Working instruction for TN 413/2 No. 1

Please refer to maintenance manual diagram 7

Instruction 1: Check if the landing gear struts are aligned. .

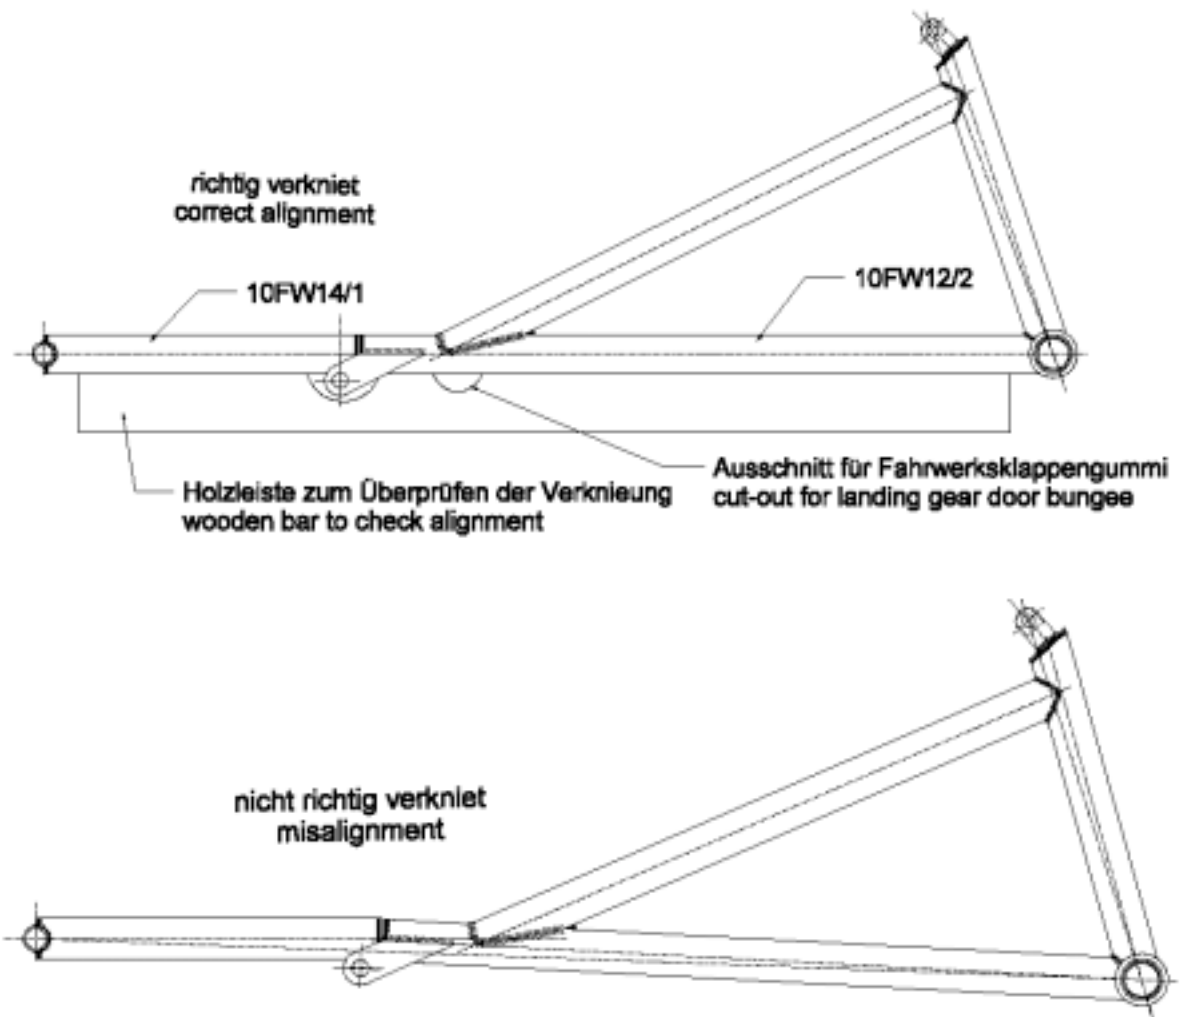
Produce a straight wooden bar according to the sketch and check if the landing gear struts are aligned for a correct over centre lock in the extended position.

The centre lines of the tubes must be exactly in line. If this is not the case, disassemble the struts at their hinge point and remove paint and if necessary file away from the metal so far that the centre lines are in line.

For reassembly use new selflocking nuts M8DIN985-8zn.

Instruction 3: Install stops for the extended position

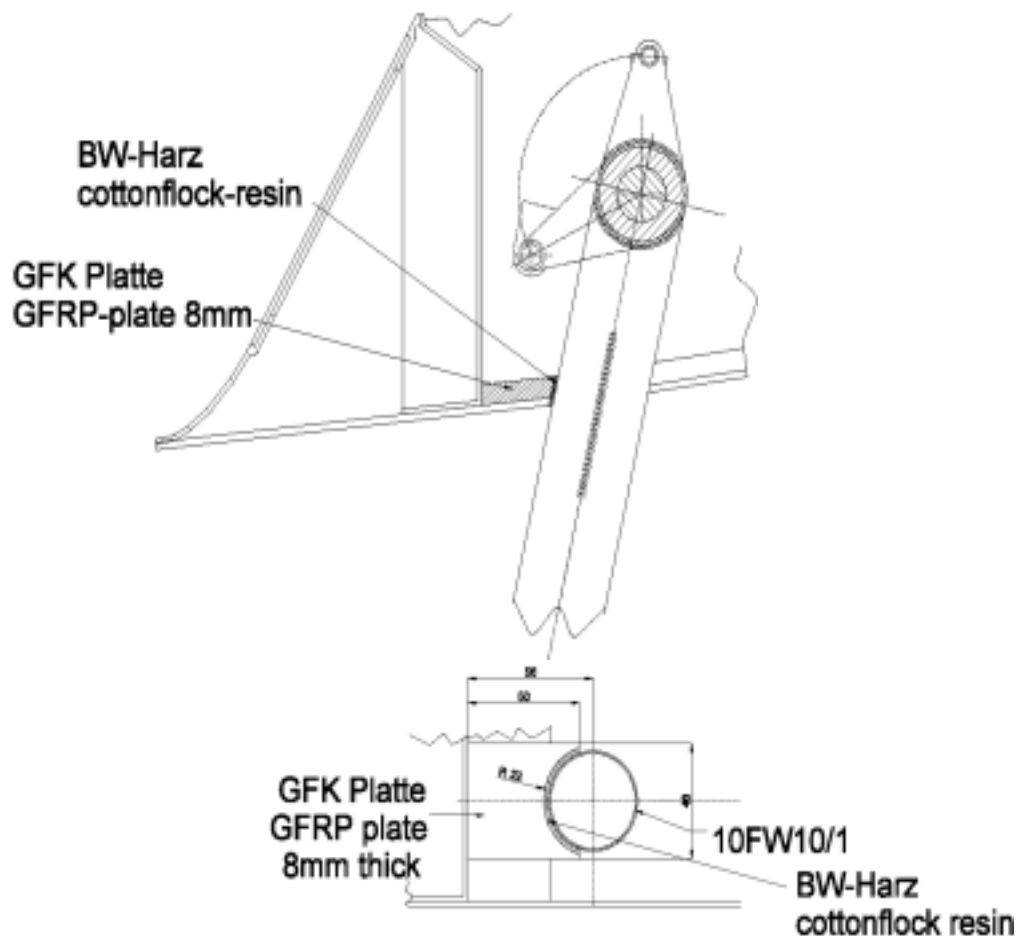
Roughen the gluing area for the pre-manufactured GFRP plates and at the plates. Glue in the plates so that there is 1mm free play to the tubes of the LG fork 10FW10/1 in the fully extended position.

After curing wax the LG fork in these areas with release agent. Apply a mixture of resin/hardener thickened with cotton-flocks into the round cut-outs of the GFRP plates and extend the LG fully. To make sure full extension pull the struts by hand into the overcentre position (downwards). After curing retract the LG and sand away excessive resin.

Instruction 4: Stop for the retracted position.

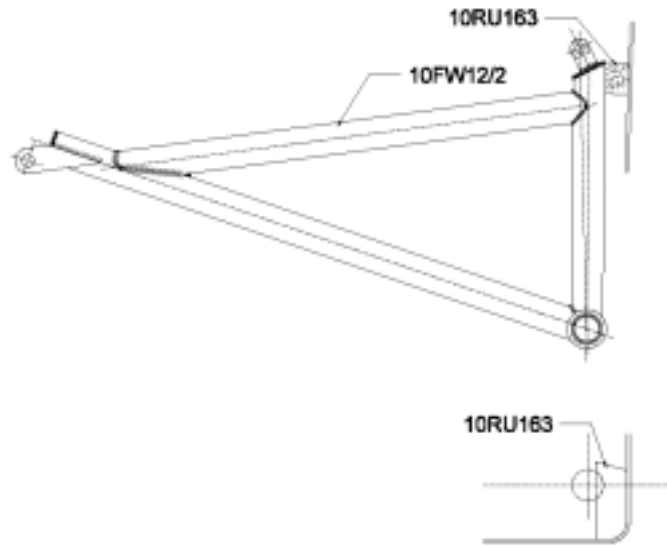
Roughen the gluing area for the stop block 10RU163 inside the LG box. (upper rear left hand side) and at the block.

Stick the block with glue film to the fork 10FW12/2. Retract the LG slowly, holding the LG doors open. Check if there is a little free play between the block and the LG box in the fully retracted position, otherwise you have to sand the block accordingly. Retract the LG again, apply resin/hardener thickened with cotton-flocks to the block, then retract the LG fully, make sure that the struts are overcentre

After curing extend the LG and sand away excessive resin.
